Remarks

Appl. No. 09/956,954
Amdt. dated October 20, 2004
Reply to Office Action of July 13, 2004

Annotated Sheet
Showing Changes 7/7

FIG. 12

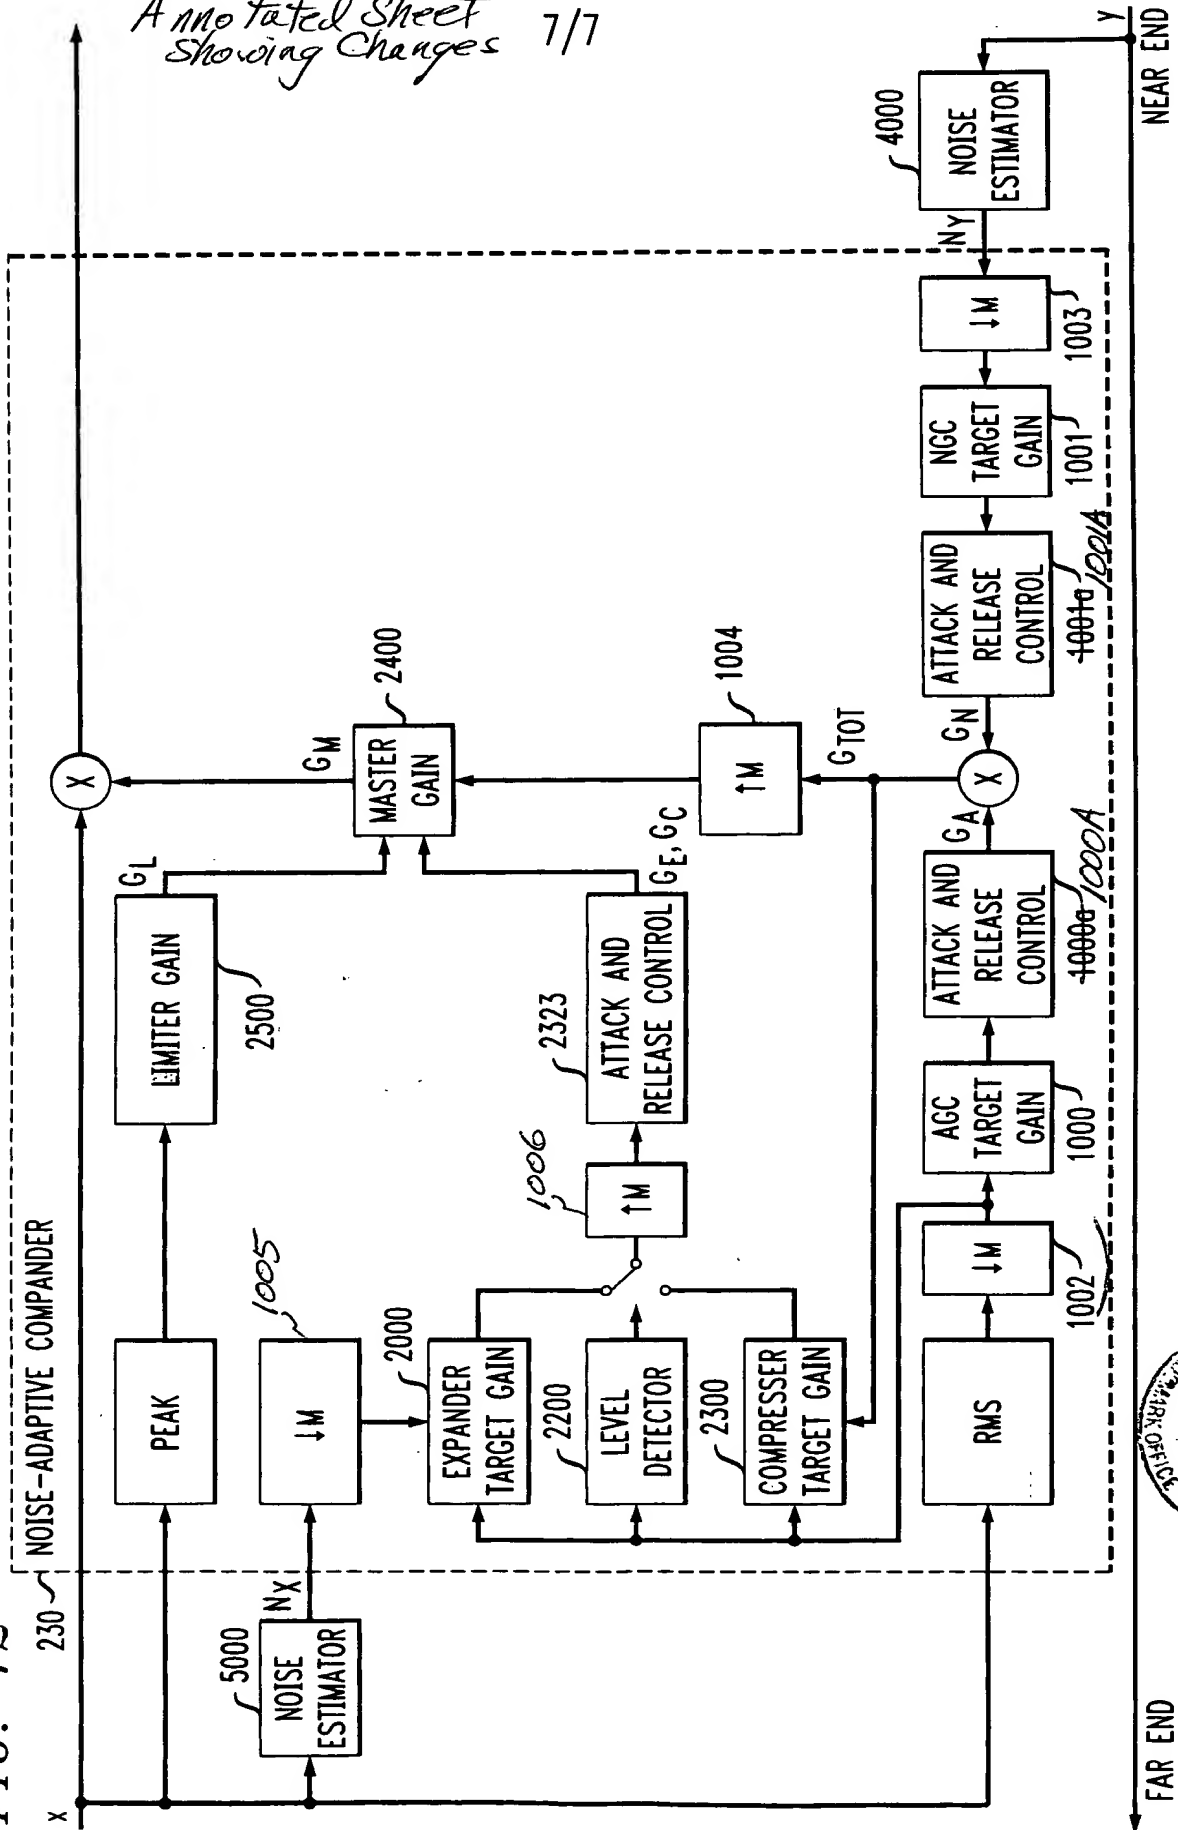
Paragraph [0073] is amended to correct typographical errors in referencing units in Fig. 12. Fig. 12 illustrates unit 2200 as a level detector and unit 2000 as an expander. Reference to unit 2200 as an expander is amended to correctly reference the unit 2000 as the expander in two places in paragraph [0073]. In the first location to be changed, the second sentence of paragraph [0073] is amended: "For example, compander 230 comprises both near- and far-end noise estimators 4000,5000, and AGC gain unit 1000, and NGC gain unit 1001, expander, compressor and limiter gain units ~~2200~~2000,2300,2500 along with a master gain unit 2400." In the second location to be changed, the sixth sentence of paragraph [0073] is amended to read: "For one thing, attack and release control unit 2323 is associated with both the expander and compressor gain units ~~2200~~2000, 2300." Also, it was inadvertently stated that "...units 100, 101, 200-500 shown in FIG. 3 also comprise attack and release control units..." Master gain unit 400 should not have been included in this group since the corresponding master gain unit 2400 of Fig. 12 does not illustrate the use of an attack and release control. This inadvertent error is corrected by amending the text to read "...units 100, 101, 200, 300, and 500 shown in FIG. 3 also comprise attack and release control units..." Also, Fig. 3 illustrates unit 200 as an expander. The seventh sentence of paragraph [0073] is amended to properly reference the expander as unit 200: "As envisioned by the present invention, the compander 23 shown in Fig. 3 would necessarily use separate attack and release control units for each of the expander and compressor gain units 200,300,500."

FIG. 10

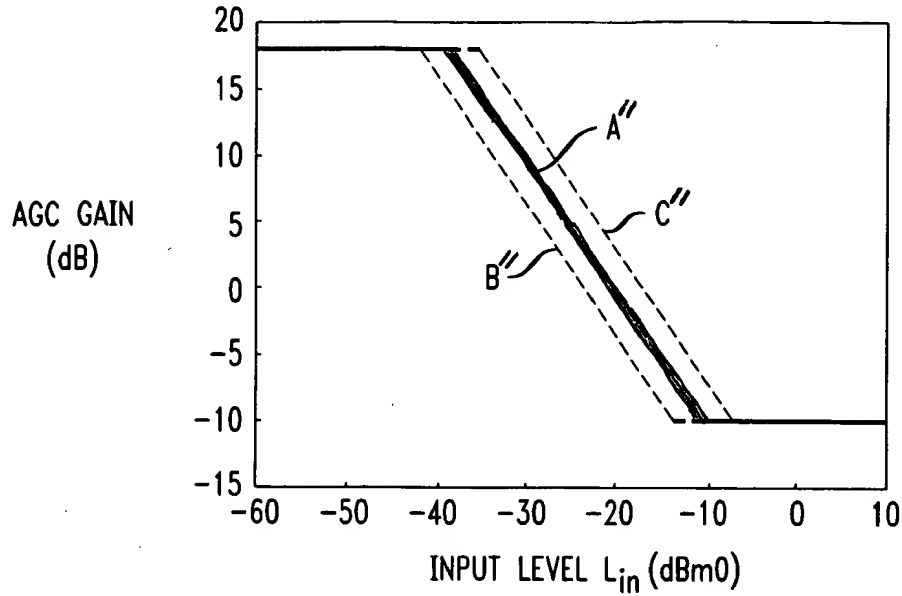
In paragraph [0069], the curves labeled A, B, and C of the last sentence of paragraph [0069] have been relabeled A", B", and C" to differentiate the curves of Fig. 10 from the curves labeled A, B, and C of Fig. 4.

FIG. 7

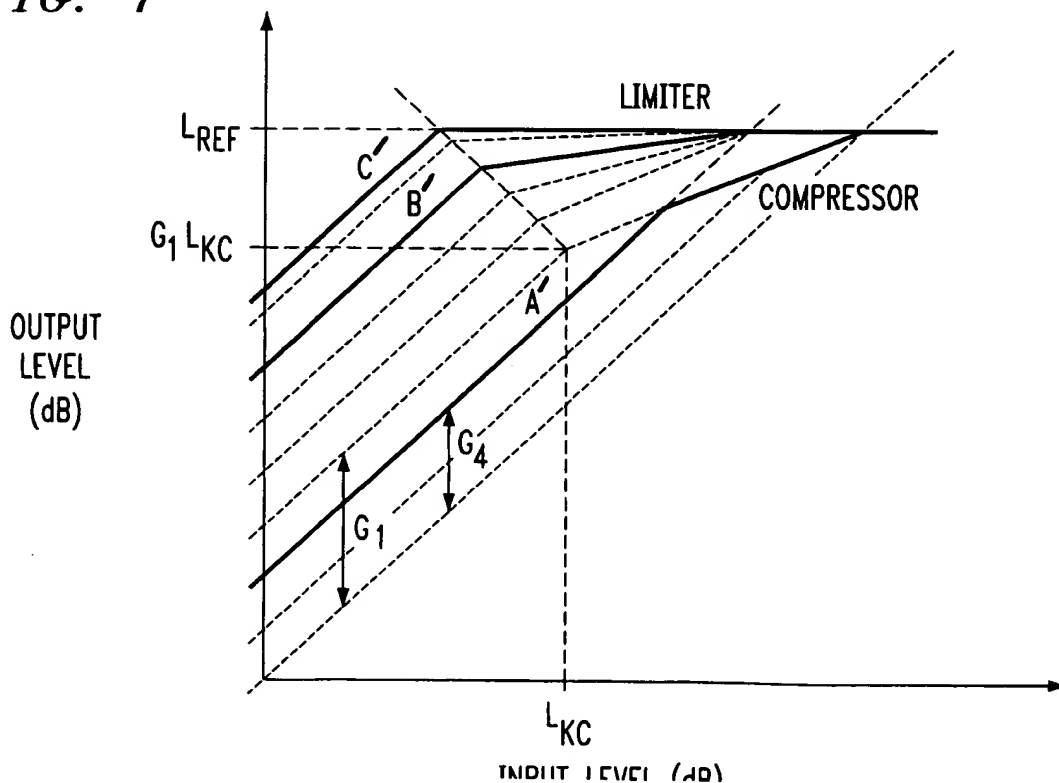
Paragraph [0053] is amended to identify the curves of Fig. 7 as curves A', B', and C'.
